Title		
<b>Demodulator Preamp</b>		
Size	Number	Revision
B	D040179-A	A
Date:	6/25/2004	Sheet 1 of 2
File:	C:\User\...\DemodPreamp.SchDoc	Drawn By: Daniel Sigg

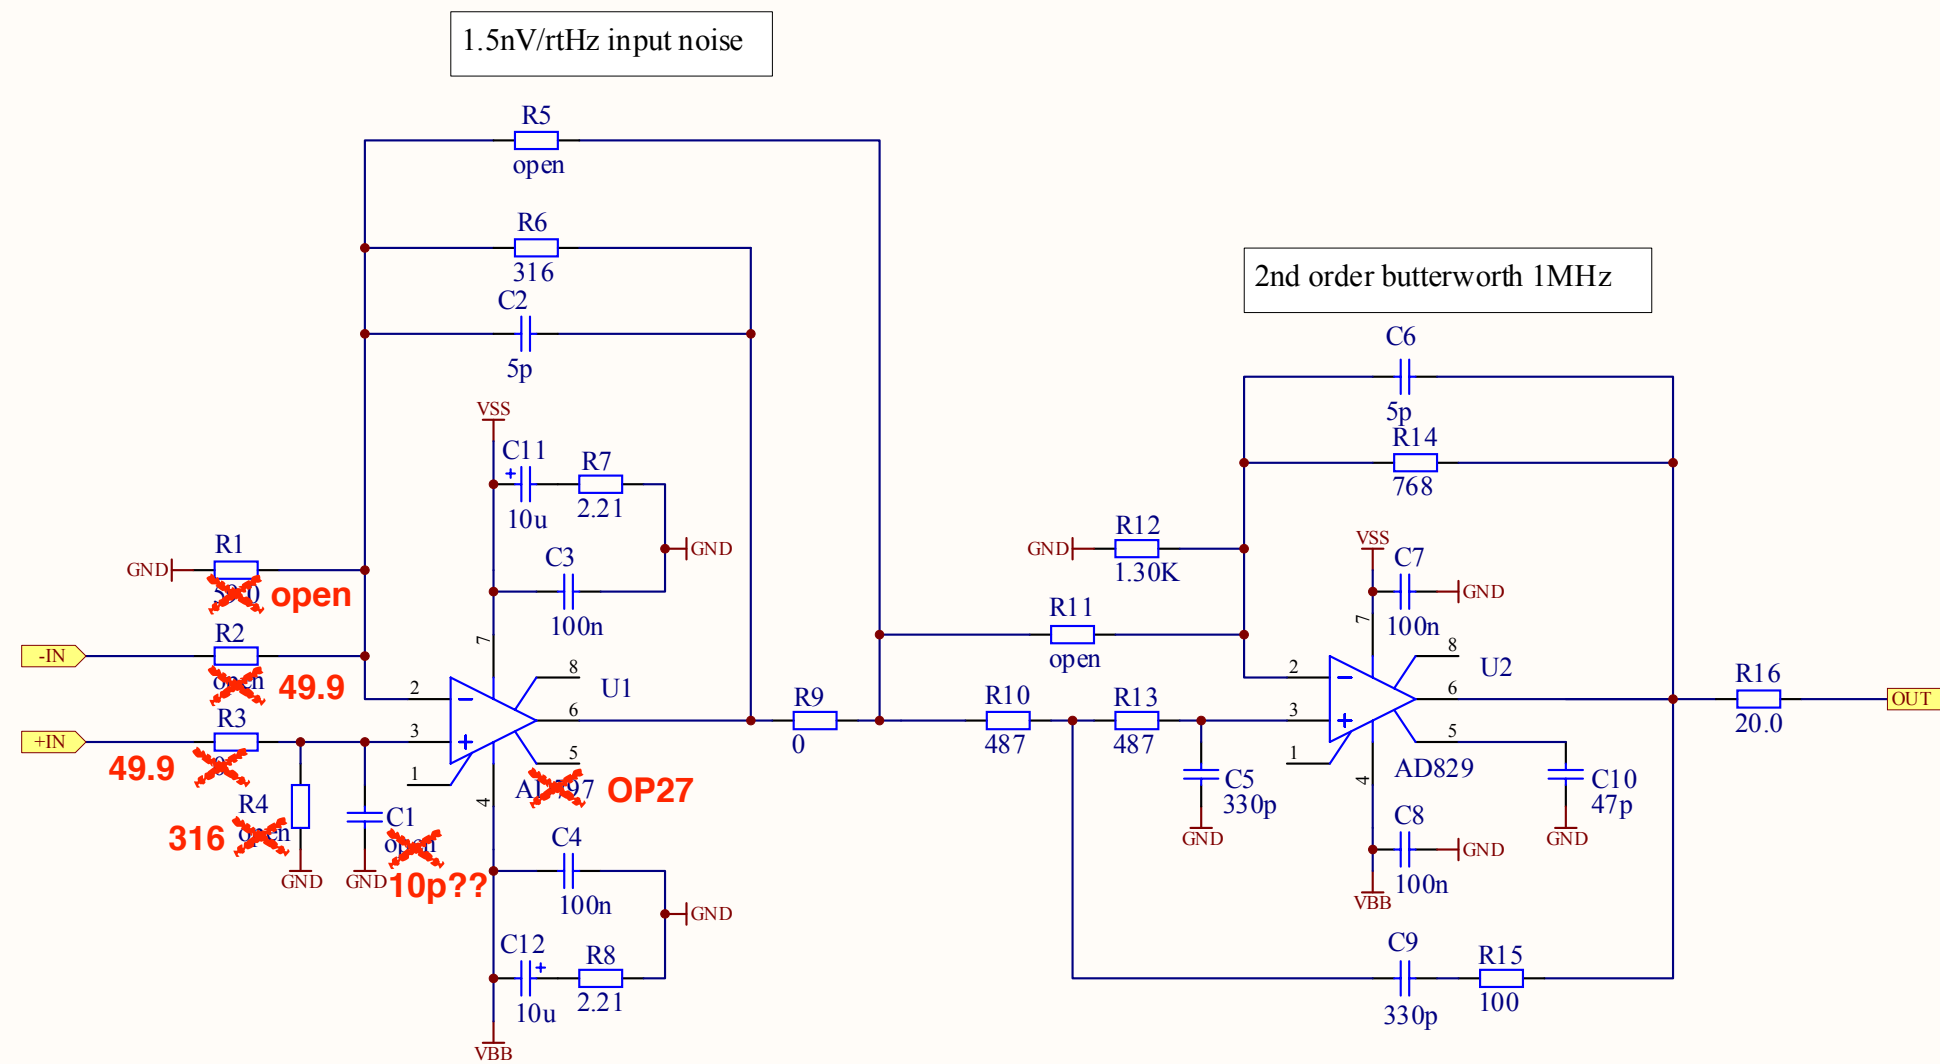
- Daughter board on AS55 Demod Board @ 40m
  - All thick film resistors changed for thin film
  - AD797s swapped out with OP27s
- gv, 11 Oct 2017
